**METROPOLITAN GOVERNMENT OF NASHVILLE AND DAVIDSON COUNTY**

**STAFF RECOMMENDATION**

**2623 Essex Place**

**Application:** New construction-infill

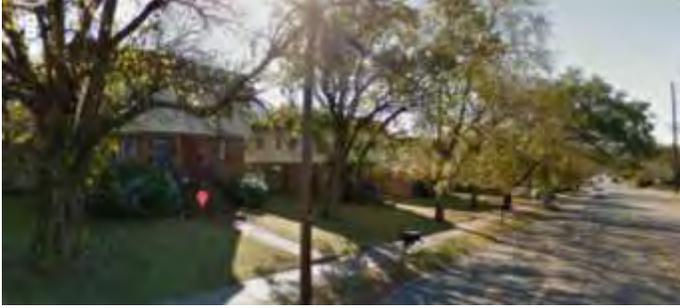
**Background:** The properties listed as 2623 Essex Place, 2116 Natchez Trace, and 2118 Natchez Trace currently have three non-contributing two-story duplexes that face Natchez Trace. The East-West property line between the two northern lots will be reoriented to North-South so that they both face Essex, with the rear halves of the lots becoming 2623 Essex Place and the front halves becoming 2625 Essex Place. Staff found this orientation to be appropriate as it follows the earlier development of the neighborhood. This project is for building "A" on the site plan. Although a garage is shown on the site plan, the design of it is not a part of this review.

The site plan also shows new construction at 2118 Natchez Trace, building "C" on the site plan, which is not part of this review.
